Revising Stations on the Interborough Express Line

By John Pegram¹

The MTA should consider revising its plans for stations at the Brooklyn end of the Interborough Express (IBX) line. It should drop the Brooklyn Army Terminal station, move the 4th Avenue station and optimize transfers with the N line at 8th Avenue.

MTA Proposal for Brooklyn-End IBX Stations²

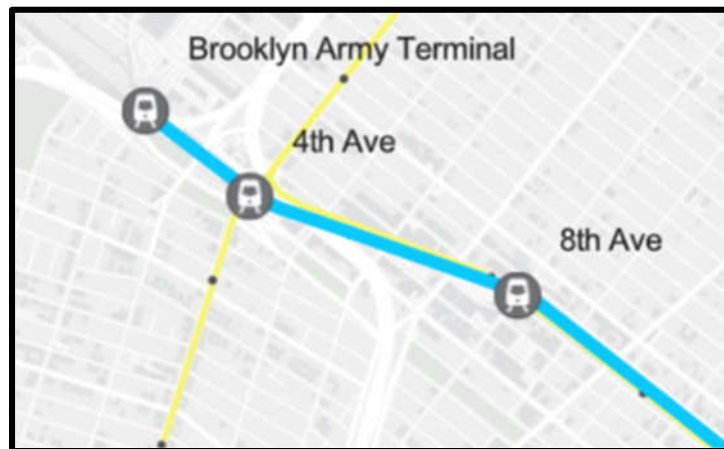
The present station locations are indicated on the map below, where the IBX line is represented in blue. The R subway line, under 4th Avenue, is indicated in yellow. The N subway line parallels the IBX line from the lower right corner of the map (south-east), and then turns between 4th and 5th Avenues to head north under 4th Avenue.

Proposed 4th Avenue Conventional Rail Station⁸

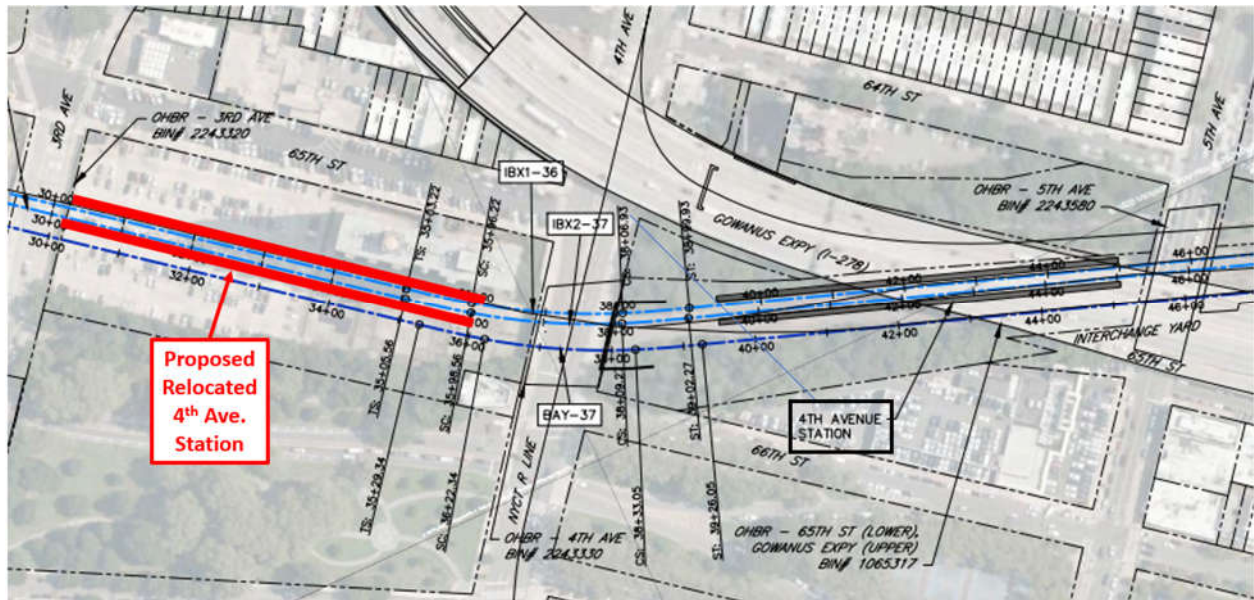
The MTA has proposed a 4th Avenue station, to be located between 4th and 5th Avenues, under the Gowanus Expressway, indicated in black dark grey on the map below. As discussed further below, I suggest relocation of this station to be between 3rd and 4th Avenues, indicated in red below.

The MTA reports have not proposed an in-system transfer to the R line at 4th Avenue. From a transit operations perspective, it would not appear to make sense to build a new R line station there, where the R and IBX lines cross. However, the nearest R line station is a fairly long walk away, at Bay Ridge Avenue. An MTA neighborhood map indicates the R line station there is 5-6 minutes from the proposed IBX 4th Avenue station,⁹ as shown below. Probably too far to attract many transferring passengers.

There does not appear to be any particular reason to locate the 4th Avenue IBX station nearer to 5th Avenue, below the expressway, as presently planned, other than spacing from the proposed IBX station at BAT. I suggest consideration of locating the 4th Avenue station between 3rd and 4th Avenues, where the right-of-way is under a platform supporting the Bay Ridge Towers parking lot. (See below).¹⁰

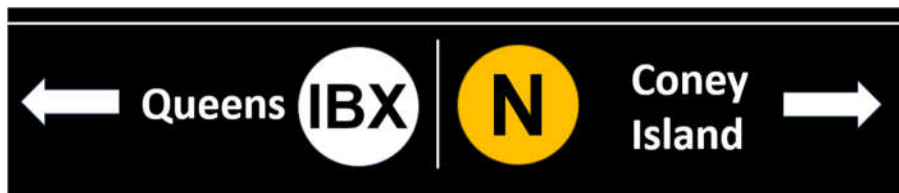
An IBX station entrance at 3rd Avenue would be a particularly good location. An entrance there would be little more than a long block walk from the south end of Brooklyn Army Terminal at 2nd Avenue. Also, the B37 bus route runs along 3rd Avenue. If run more frequently than now, buses on that route could provide convenient access to locations along the entire waterfront and into Bay Ridge.

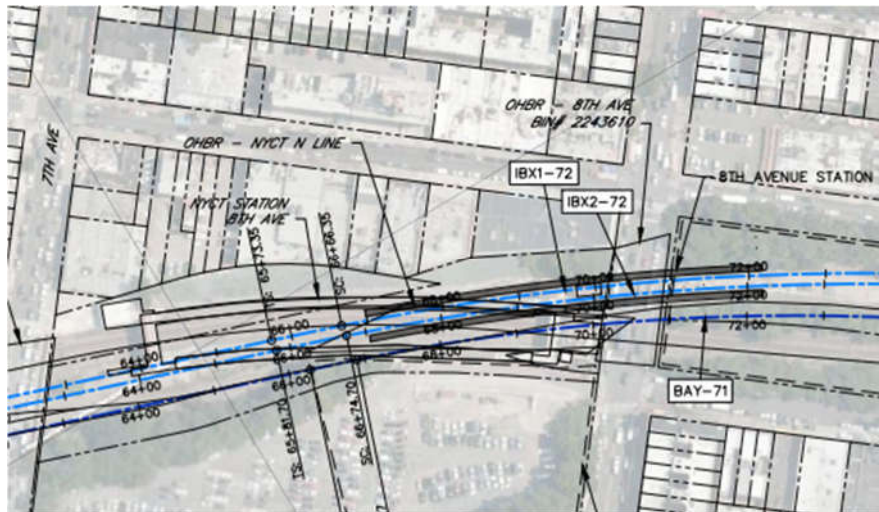
Currently, the MTA proposes to place the 8th Avenue IBX station under the existing N line station and 8th Avenue, as shown below:¹¹

The existing railroad and subway right-of-way is wide enough at 8th Avenue to permit a four-track transit station there at the level of the current N line station, allowing for cross-platform transfers between the IBX and N lines. There appears to be enough distance either side of that station for the IBX tracks to rise up to that level. If costs make that arrangement impractical, at least up-escalators and elevators should be provided to expedite transfers directly between the IBX platforms and the N platforms at the 8th Avenue station.

Ideally, a cross-platform transfer between IBX and N lines should be provided at 8th Avenue.
